BUILDING REMEDIATION

140-142 NORTH STEYNE MANLY 2095 SP44636

DEVELOPMENT APPLICATION- SECTION 4.55

ORIGINAL DA REMOVED THE BIN STORE TO BE REBUILT BUT NOW WILL NOT BE REBUILT AS BINS MOVE INTO BASEMENT.

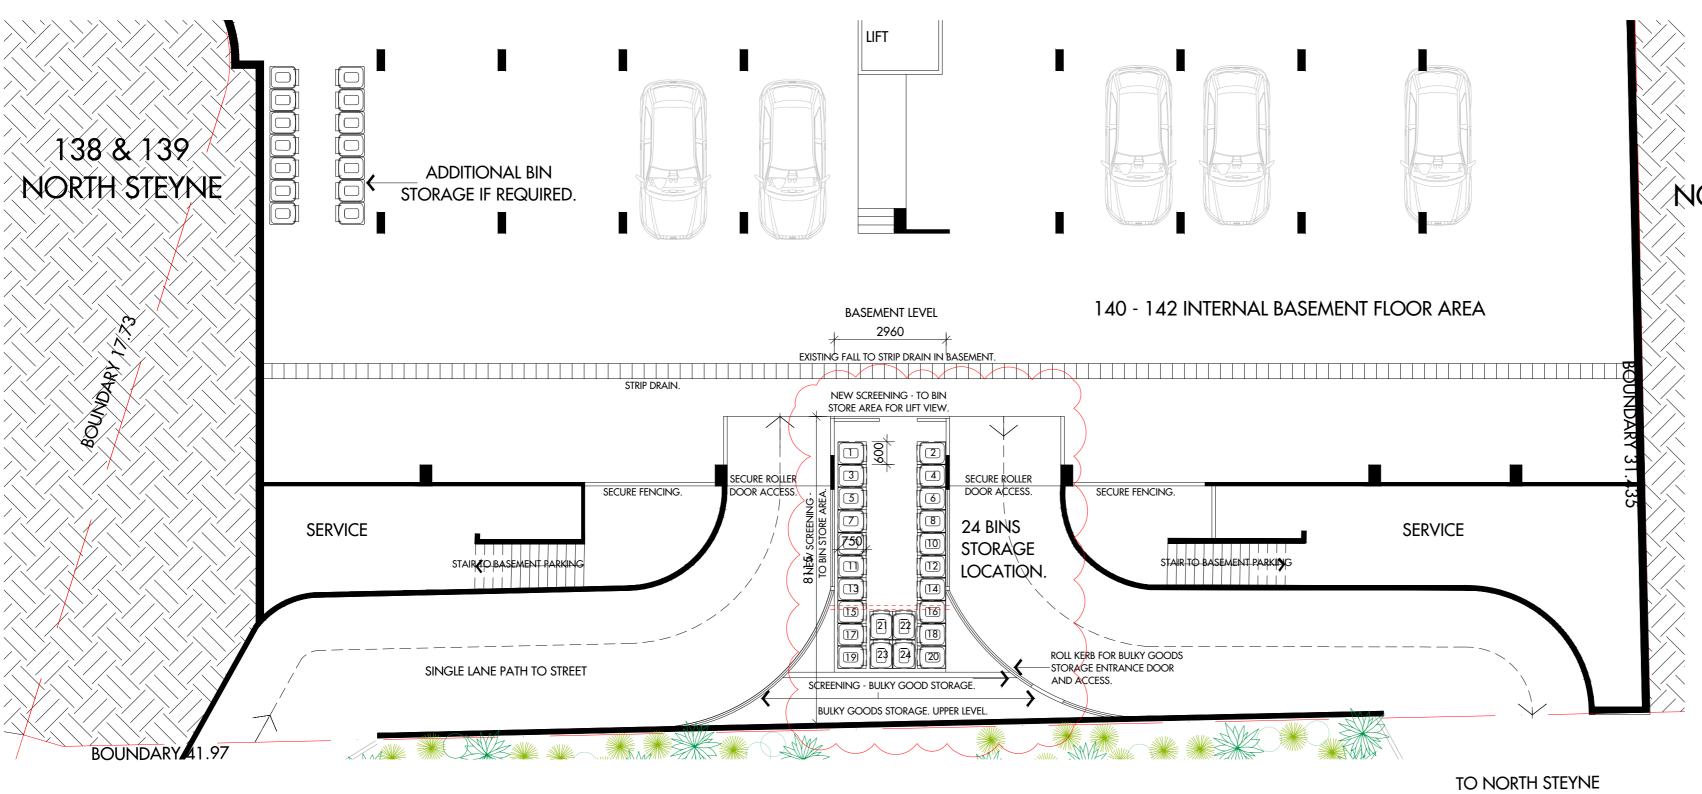
NEW SCREENING - TO BIN STORE AREA.
EXISTING STEEL SCREENING IS RUSTED AND IN
NEED OF REPLACEMENT.
NEW SCREENING - VERTICAL SLATS ALUMINUM FINISH POWDER COAT IRONSTONE
TO MATCH FACADE.

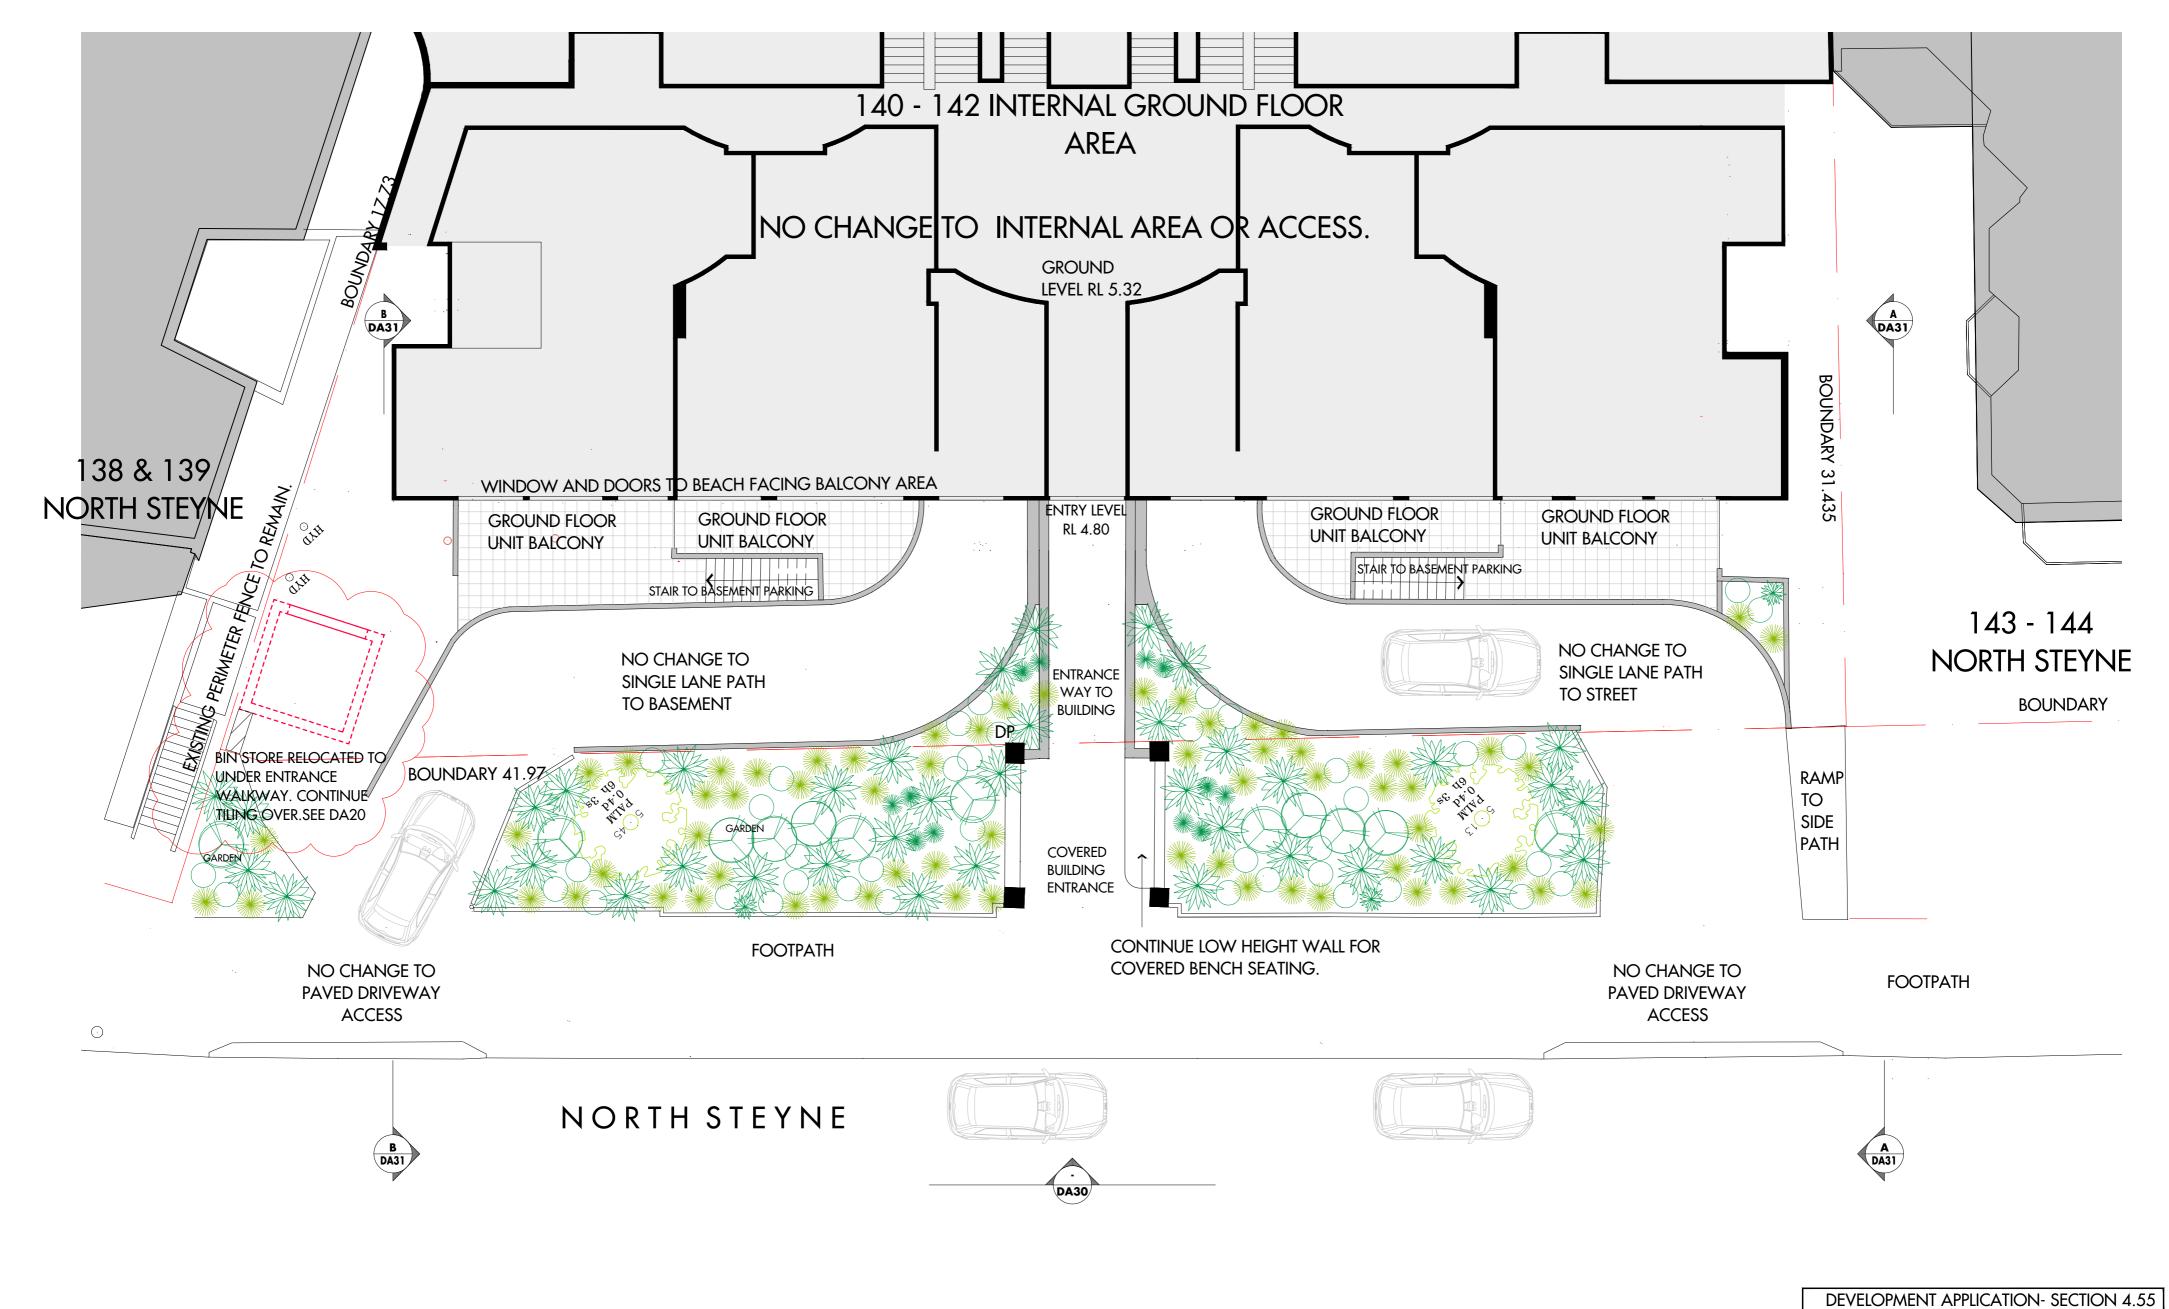
EXISTING INACCESSIBLE VISITOR SPACE. SPACE MEASURE 4.5m X 2.4m WITH THE LIFT ACCESS INFRONT - A CAR IS NOT ABLE TO REVERSE INTO THE SPACE.
